Proposed changes to 802.3ca - D2.0 PMA figures 142-19 & 142-20

Proposed changes to D2.0 PMA Figures 142-19 & 142-20

Figure 142-19—Differential encoding

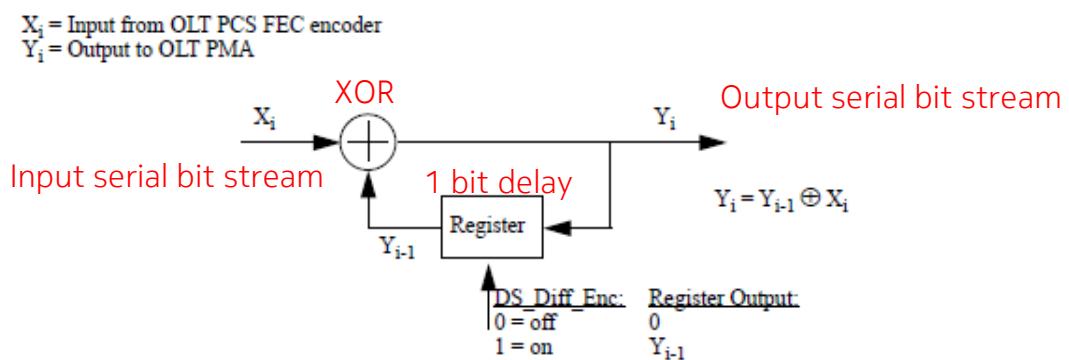
- Propose to add notes to Figures 142-19 and 142-20 to address concerns raised in comment #387

Current D2.0 PMA figures (black) & proposed changes (Red)
